CS Memorandum No. 1401

Subject: Configuration Management Board Meeting No. 118

CMB Meeting Minutes #118

SUBJECT: Configuration Management Board Meeting # 118 – Rev. No. 0

SHEET
JG-04

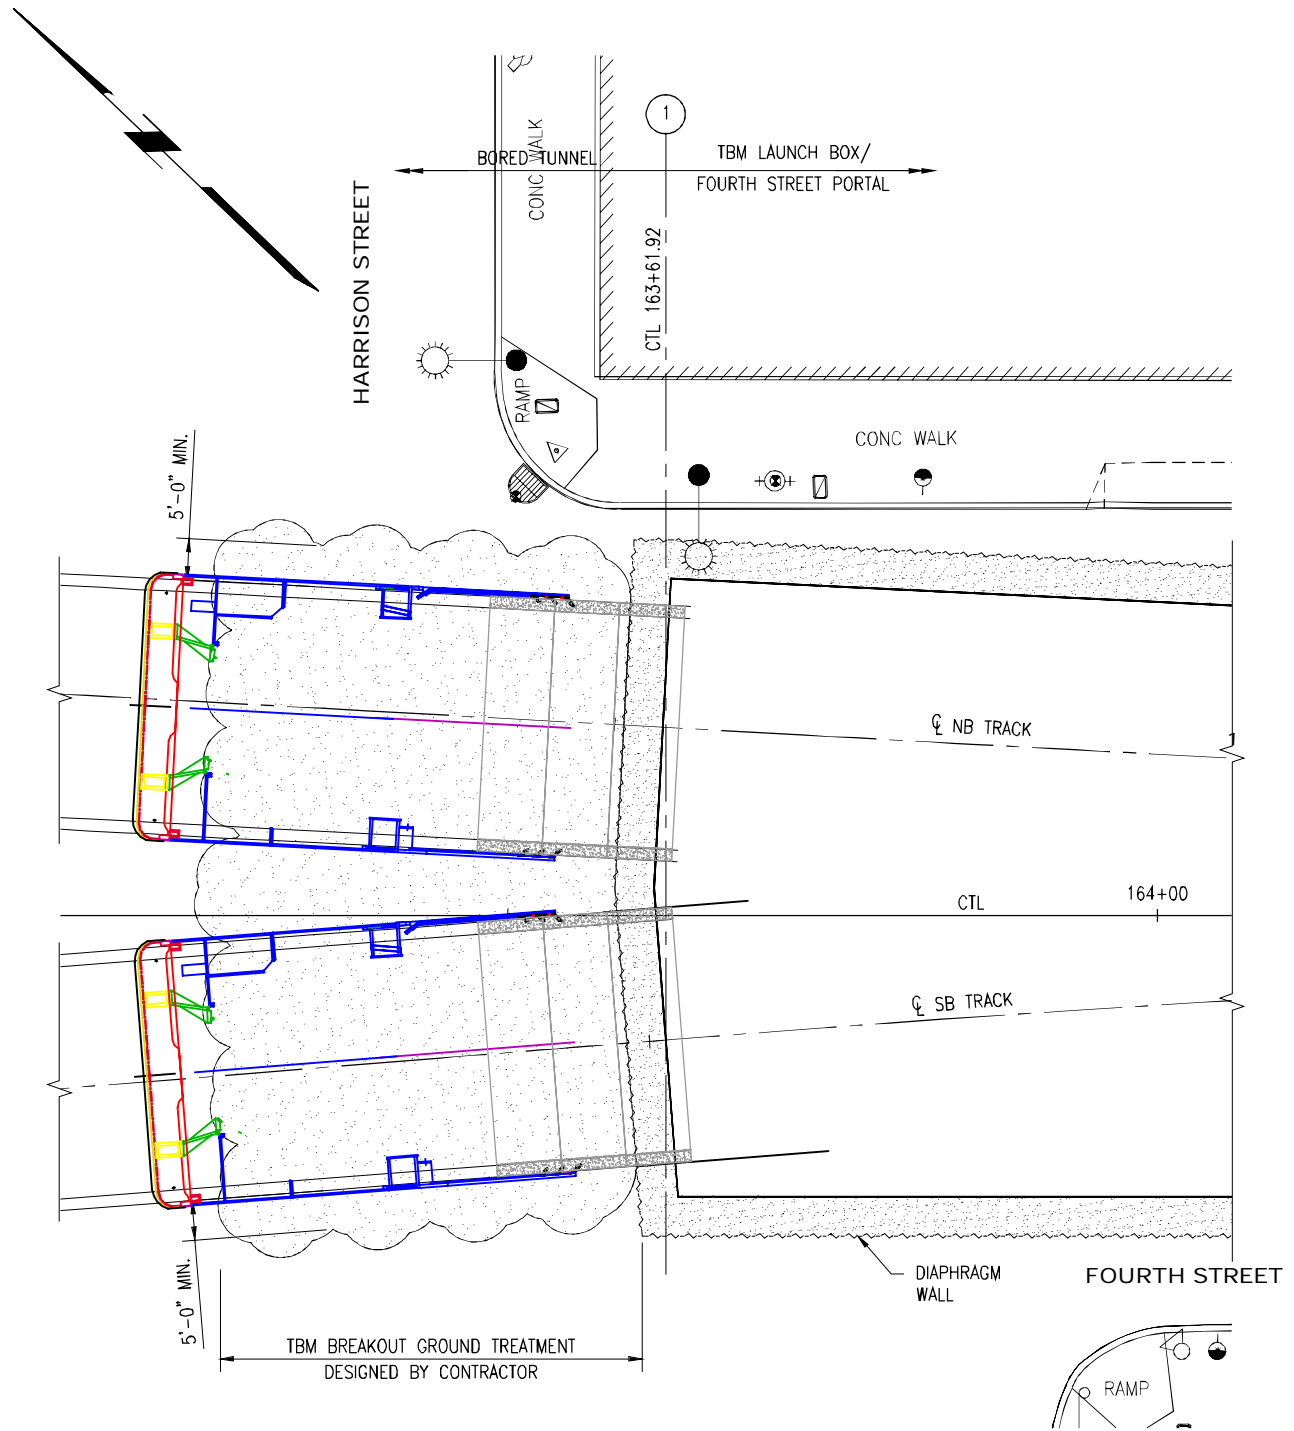
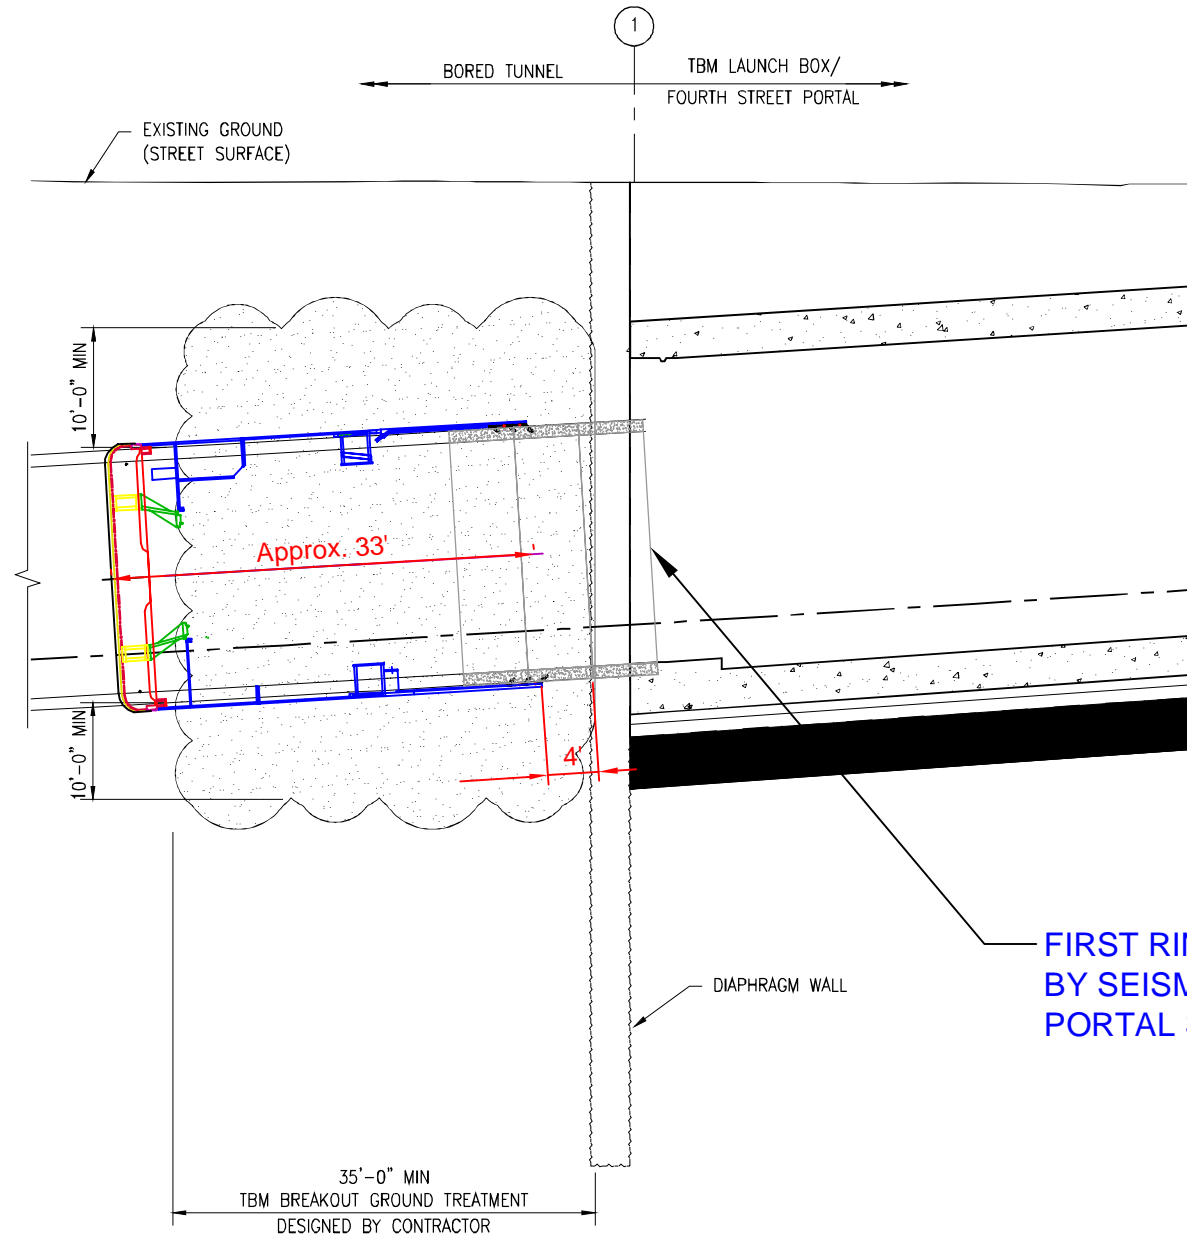
Contract Drawing ES-163 Rev. 1 provides minimum dimensions for the extent of the ground treatment for the TBM launch box. A note on the plan and section view of the drawing also indicates that the TBM Breakout Ground Treatment is "Designed by Contractor." Note 8 on the same drawing states, "Grout to be designed by the Contractor. The Contractor shall develop the proposed grouting plans based on the conditions at the TBM Launch Box and the requirements shown on this sheet. The Contractor shall submit the proposed grouting plans to Engineer for review and approval."

The main purpose for having a Soilcrete breakout zone is to provide relatively impermeable ground for the TBMs to start mining within. The minimum dimensions were not sufficient to produce a large enough Soilcrete breakout zone for a safe TBM breakout because the overall length of the TBM shield and cutterhead exceeds the minimum length shown in the Contract Drawings (see attached drawings). The zone must be sized to allow installation and backfill grouting of at least one ring of the tunnel liner to provide a watertight seal to develop between the treated impermeable ground and the tunnel liner. Once a satisfactory seal has been developed, the TBM may safely exit the improved ground with a reduced risk of water and soil inflow into the tunnel/TBM Launch Box interface. The lack of a sufficient seal in un-improved ground would result in water and soil inflow which would likely cause significant and potentially catastrophic ground settlement at the breakout (i.e. the intersection of 4th and Harrison). The Contractor has designed the minimum jet grout layout to provide for the development of a sufficient seal. The design allows for the encapsulation of the TBM and one ring with

only 1.8' of cover between the TBM cutterhead and edge of jet grout. The Contractor will also provide additional protection by installing a breakout seal prior to mining.

PLEASE PROVIDE 1) QUANTITY CALCULATION
2) HOW DID A LUMP SUM DESIGN BECOME A UNIT PRICE QUANTITY.

TBM'S SHOWN MINED TO A POSITION WHICH ALLOWS FOR ONE FULLY GROUTED RING WITHIN THE IMPROVED GROUND

DRAWING NO. CS 1252 - 031
COR 076

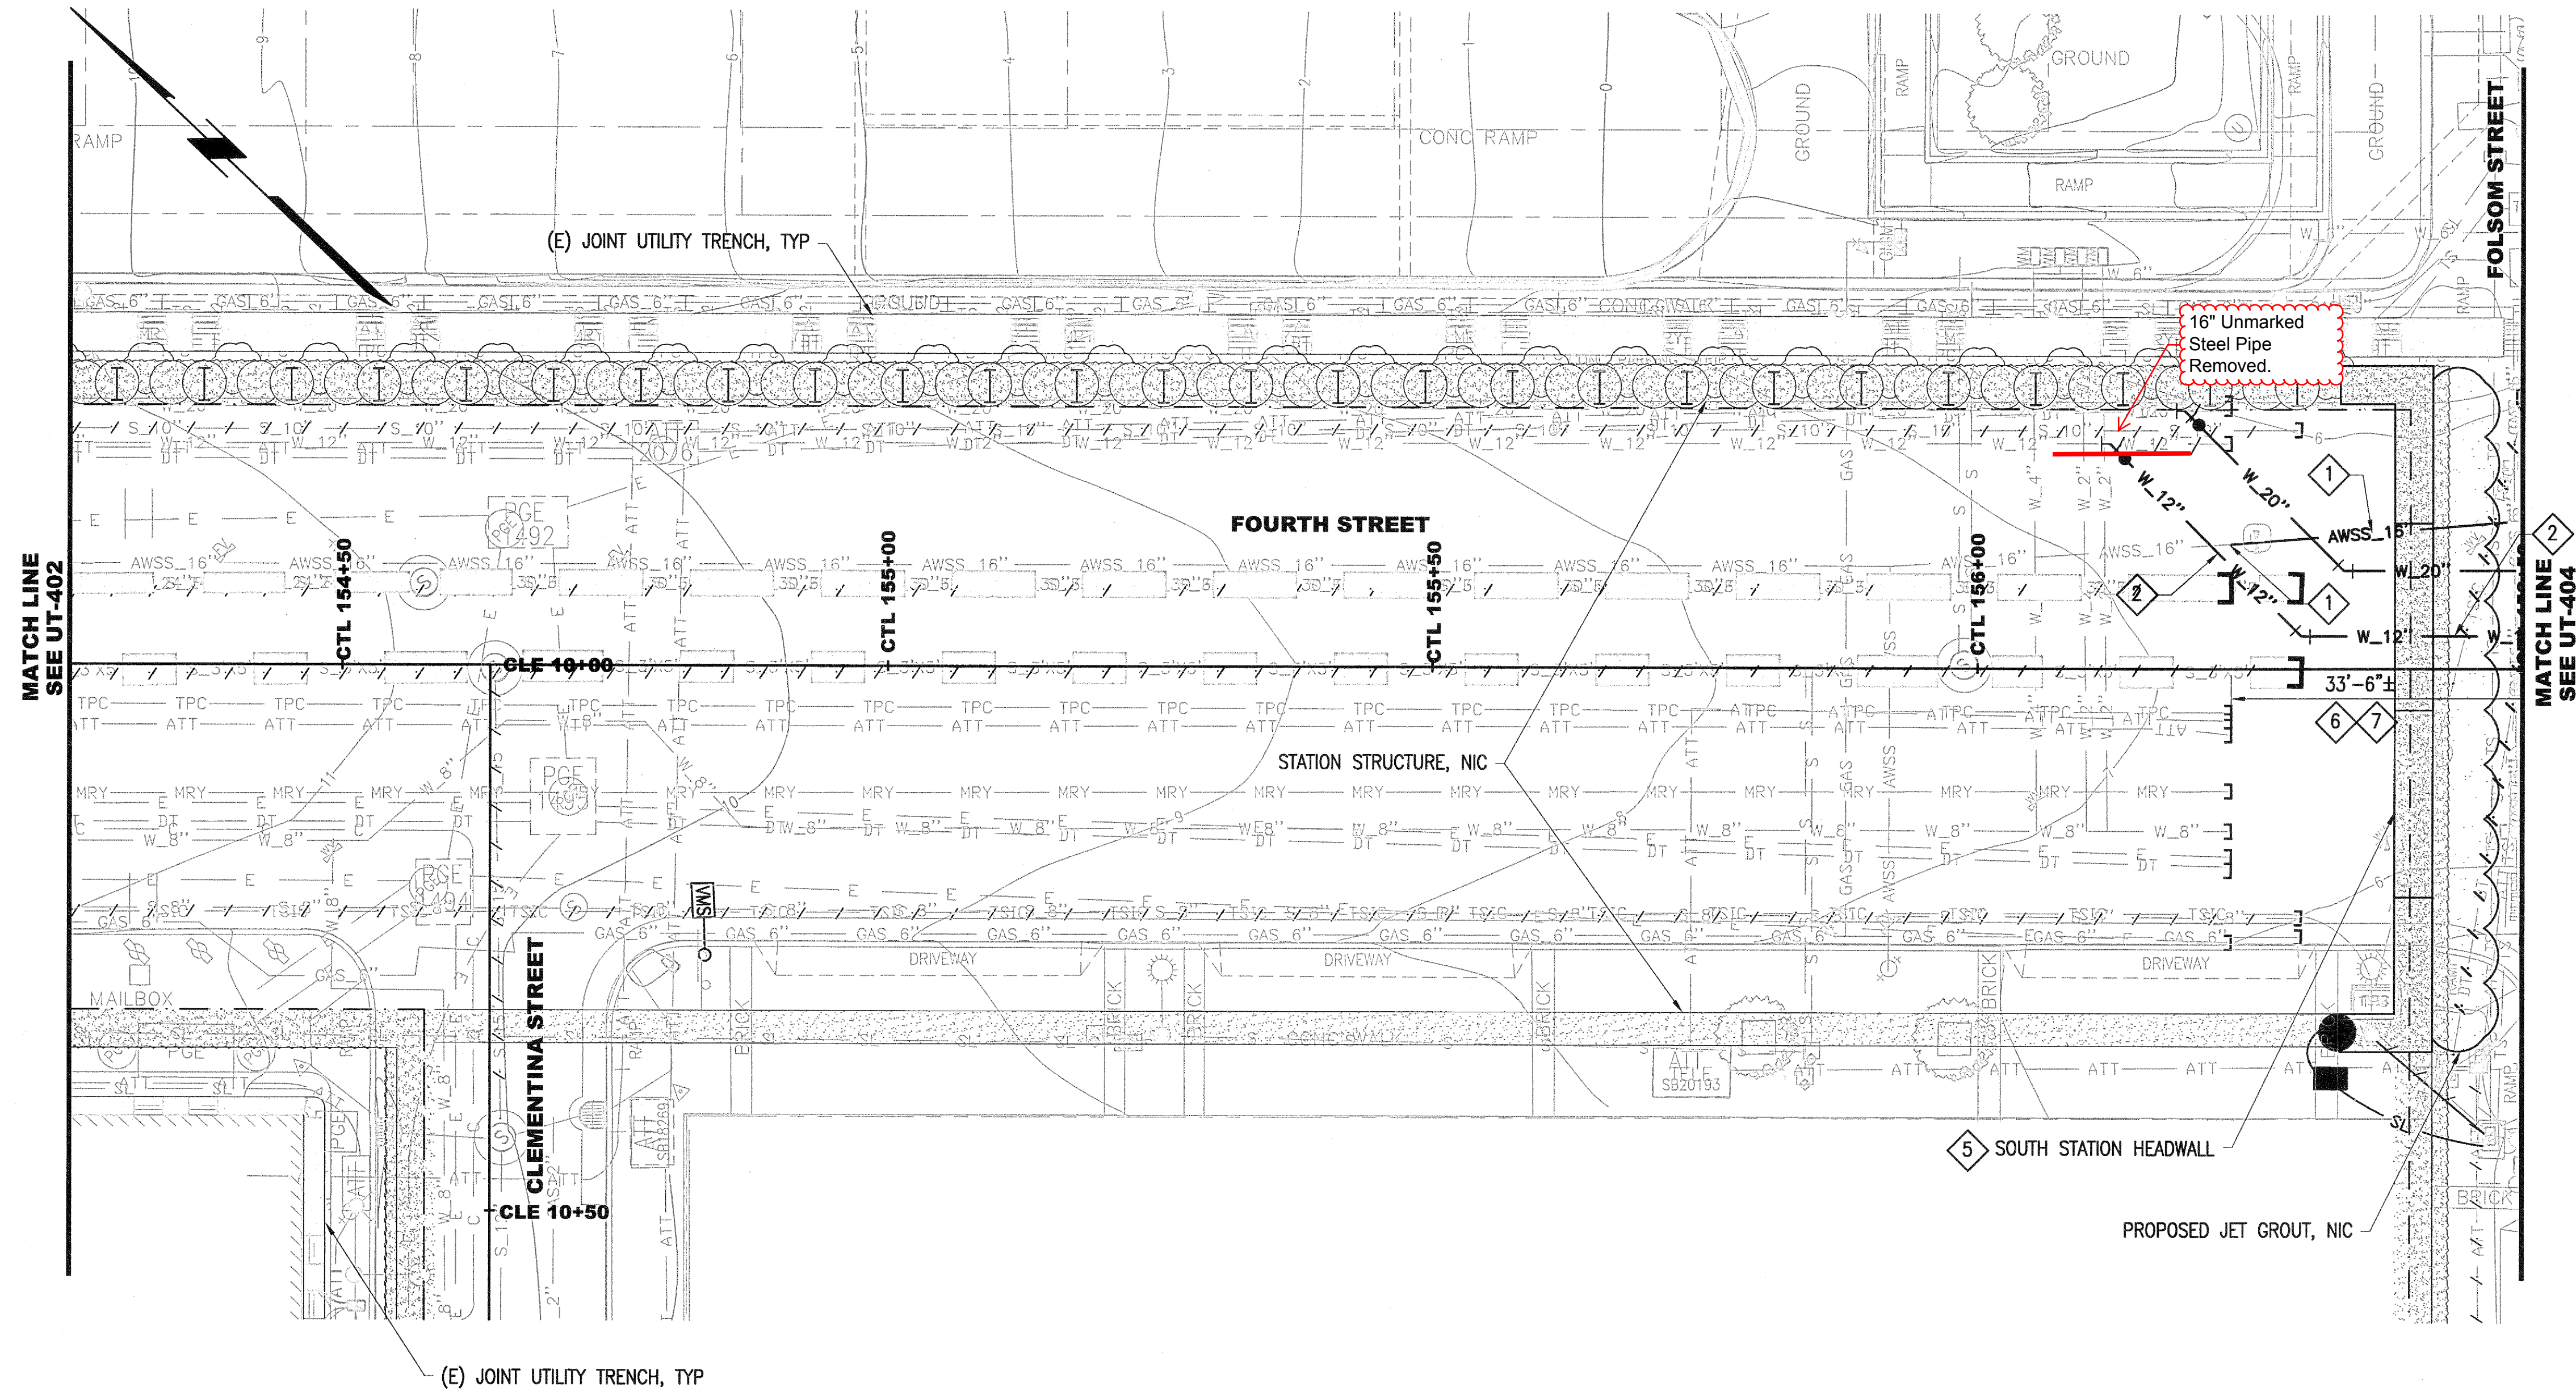
Facts: The Contractor encountered an abandoned 16" pipe located in the trench of the proposed 12" low pressure waterline. The 12" waterline could not be installed until the abandoned 16" pipe was removed. The 16" steel pipe was removed at the 12" water tie-in location at the north side of the Moscone southeast headwall. See attached Drawing CS 1252 - 31.

Justification: The contract drawings, specifically WD-403 rev.0 and UD-403 rev.0, did not show the abandoned 16" pipe which constitutes a differing and unforeseen site condition. The 16" pipe was at the same elevation as the proposed 12" waterline and therefore needed to be removed. SFTMA inspectors have verified that additional labor and equipment resources were required to facilitate removal of the 16" abandoned pipe.
